UNITED STATES
NUCLEAR REGULATORY COMMISSION
REGION III
799 ROOSEVELT ROAD
GLEN ELLYN, ILLINOIS 60137

Docket No. 50-346

SUBJECT: INSTRUMENT SYSTEM - BUILDING ELECTRICAL GROUND SEPARATION
DAVIS-BESSE UNIT 1 (F30285H1)

Attachment: Diagram

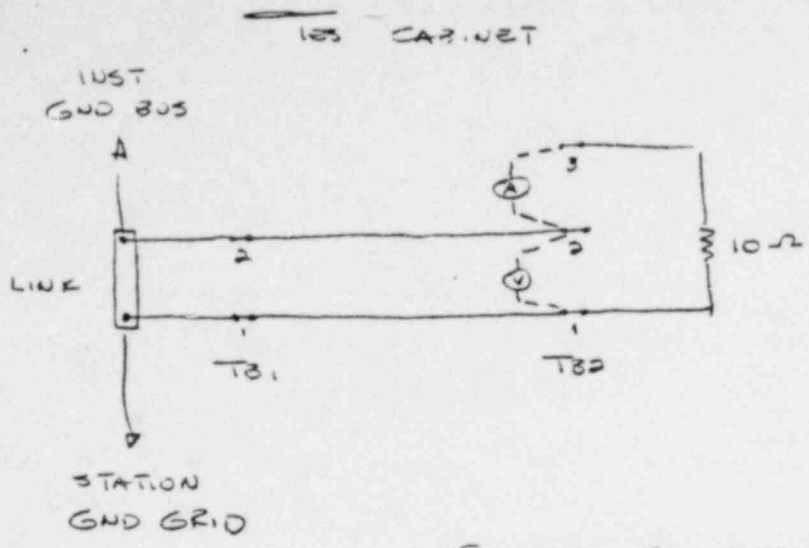
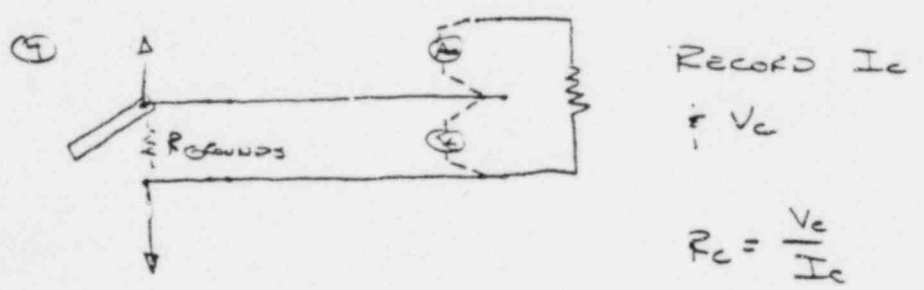
During a site inspection by RIII on April 8, 1977, the inspector determined that after a substantial amount of trouble shooting by the licensee, an effective resistance separated the two systems of only 77 ohms versus the test acceptance criteria of 10 megohms, that was specified in the test.

Another point to be made for this system is that during normal operation a bus-link is wired between the two ground systems. The value of this bus-link is less than .003 ohms. During several tests the licensee determined that up to 2 amperes of current was flowing through this link. Normal current ranges are from 3-300 millamps. Because of the potential problem of burning out sensitive measuring equipment to measure the resistance with the ground link removed, an alternate test was proposed on March 8, 1977, by Bechtel. An alternate method is shown on the attached diagram. First, the resistance of the 10 ohm resistor was checked as close as possible with the best equipment the licensee could obtain, then the resistor was placed in parallel with the ground link, and then, the ground link was removed. The licensee then measured the current and voltage. Knowing the three factors, an equivalent resistance was obtained of 77 ohms between the two systems.

RIII proposes to accept the licensee's current conditions with the assumption that the licensee can demonstrate that the ground currents being experienced on the nuclear instrumentation will not cause any safety problems for Modes 6 through 3. The licensee is very pessimistic that the value of 10 megohms can ever be attained. It is requested that your office review this subject and determine the position of I&E relative to the safety significance of operation of a ground grid with a separation of less than 10 megohms.
